RE: LPA Reference: 137226/FO/2023 and 137227/FO/2023 Detailed Response

Please see Curtin's response to ATE below:

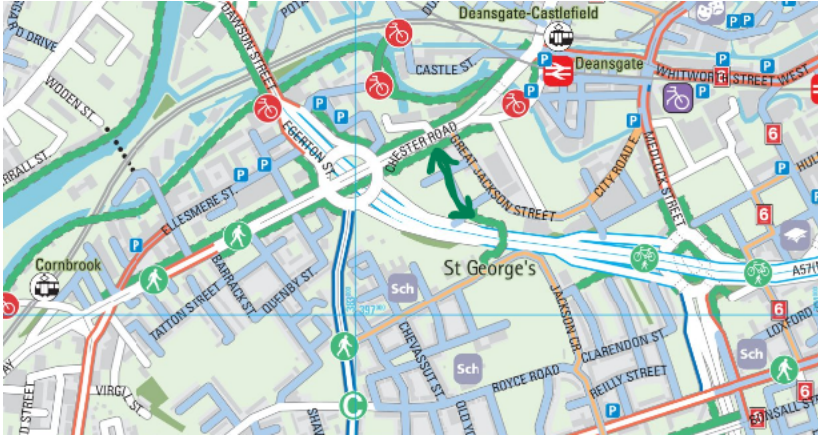
Cyclists travelling to the existing shared bridge over the A57(M) Mancunian Way from the wider cycle network will arrive from Chester Road, and via the shared route recently finished as part of Phase 2 proposals, highlighted below with a green arrow:

The following image shows the recently implemented shared pedestrian/cycle route from Melbourne Street to Chester Road through Phase 2 of the wider Masterplan:

Curtins point remains that the infrastructure proposed is suitable – in line with LTN 1/20 – and also in consistent with the design approach for Phase 2 as shown in the above image.
